DESIGN B		DART AEROSPACE LTD HAWKESBURY, ONTARIO, CANADA		
CHEC	KED #	APPROVED #	DRAWING NO. REV DSI 9354 SHEET 1 0	
DATE			TITLE SC/	NLE
06.09.25			SHOULDER HARNESS UH-1 BAR	v⊤s
Α		06.09.25	NEW ISSUE

DART SERVICE INSTRUCTION

TO AMEND INSTALLATION INSTRUCTIONS IIN-D412-702 REV.C AND DSI 9312 REV. B

D3196-5 BAR INSTALLATION

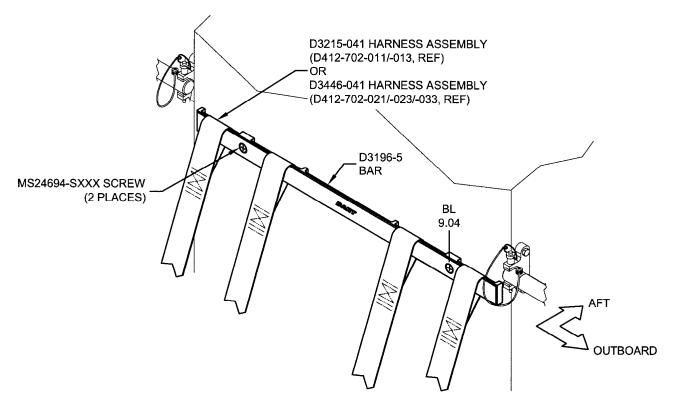
IT IS ACCEPTABLE TO REPLACE P/N D3196-1 BAR FROM THE D412-702-011/-013/-021/-023/-033 KITS WITH D3196-5 TO ALIGN WITH MODIFIED ANCHOR NUT POSITIONS ON SOME UH-1 AIRCRAFT.

WHEN INSTALLING D3196-5 BAR INTO THE AIRCRAFT, IT IS ACCEPTABLE TO USE LONGER MS24694-SXXX SCREWS INSTEAD OF THE MS24694-152 SCREWS CALLED UP IN THE INSTALLATION INSTRUCTIONS IIN-D412-702 TO ENSURE THAT THE BAR IS PROPERLY SECURED.
